BOARD OF ADJUSTMENT CASE REPORT

Case Number: **BOA-22782**

LOCATION: 6851 E KING PL N

ZONING CLEARANCE PLAN REVIEW

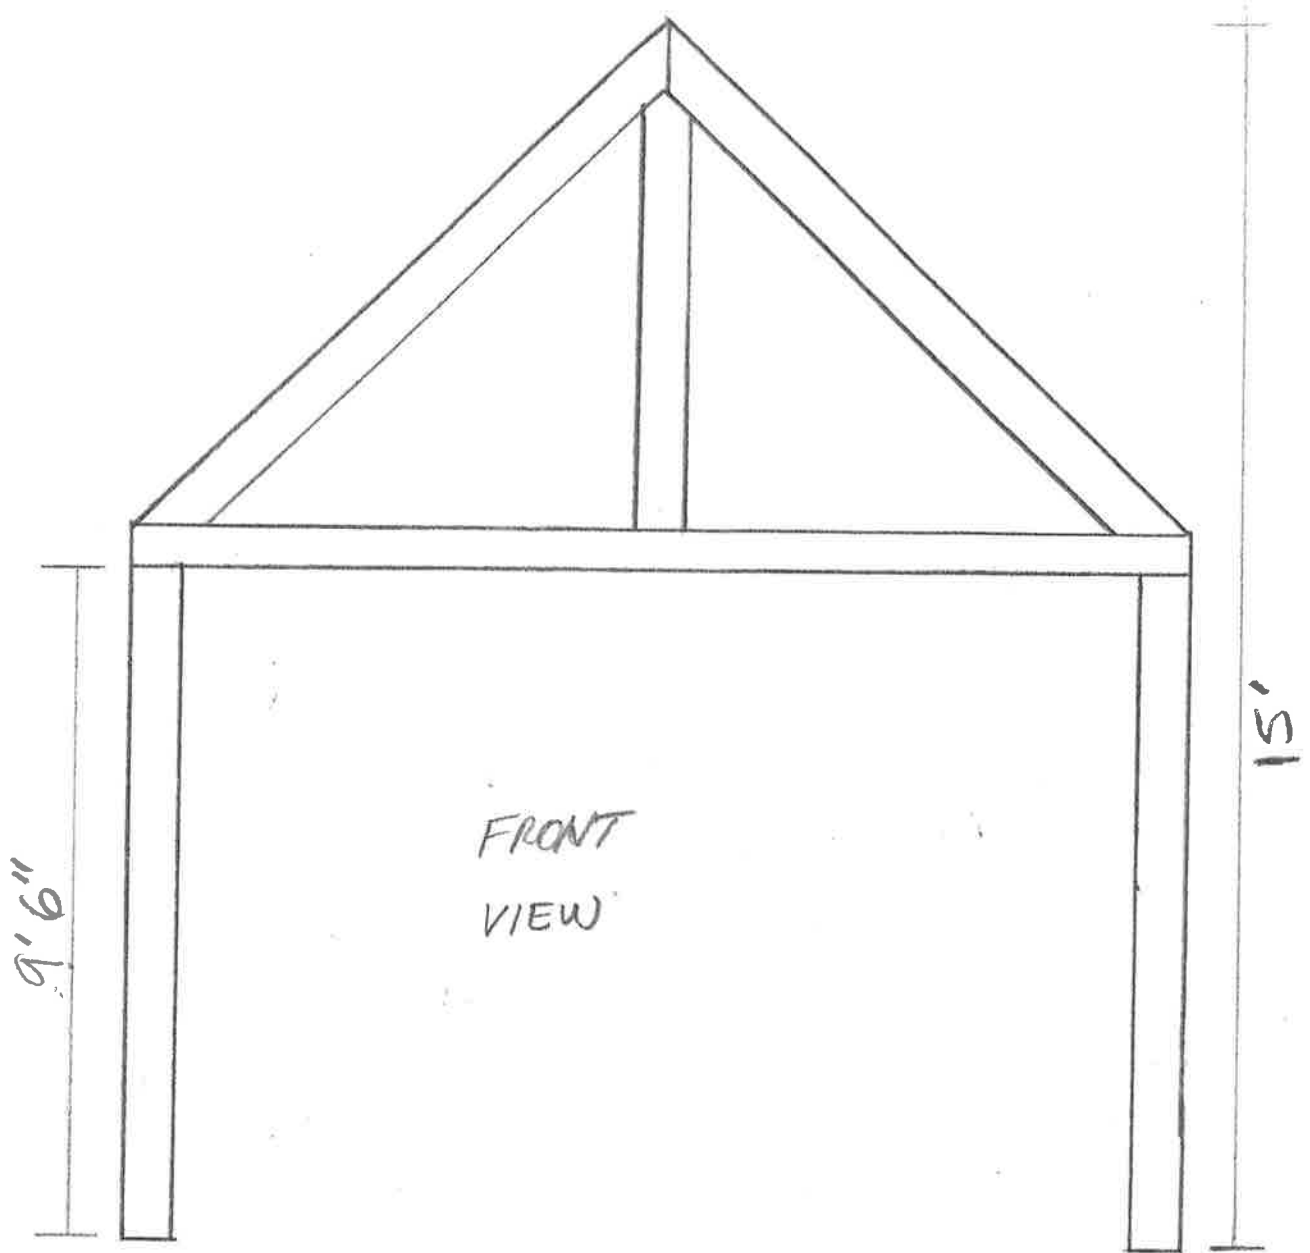
Review comment: The proposed carport is located in the street setback area and requires special exception granted by the BOA. Please contact an INCOG representative at 918-584-7526 for further assistance. Please note: the regulations underlined above must be addressed as part of the special exception process as the proposed structure is not in compliance with said regulations as submitted. If approved, submit a copy of the approved special exception as a revision to your application.
